Product Change Notice (PCN)

PCN Number: **PCN-0451204R-01**

Product(s) Affected: **PJ-057AH**

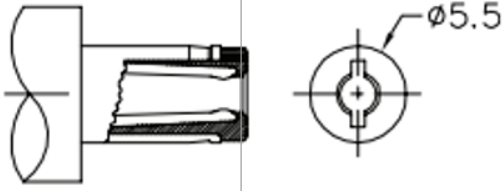
Description of Change: **Minor Housing and footprint differences. Material Change on the housing and terminals. See image Below**

| PREVIOUS CUI DEVICES DETAIL / IMAGE | | | NEW CUI DEVICES DETAIL / IMAGE | | |
| | MATERIAL | PLATING | DESCRIPTION | MATERIAL | PLATING/COLOR |
| center pin | copper | nickel | center pin | brass | nickel |
| terminal 1 | brass | silver | terminal 1 | brass t=0.40 | silver |
| terminal 2 | copper alloy | silver | terminal 2 | bronze t=0.30 | silver |
| terminal 3 | brass | silver | terminal 3 | brass t=0.40 | silver |
| plastic | PBT | | cover | PA10T (UL94V-0) | black |
| | | | housing | PA10T (UL94V-0) | black |

MATING PLUG
Jack Insertion Depth: 9.15 mm

MATING PLUG
Jack Insertion Depth: 9.45 mm
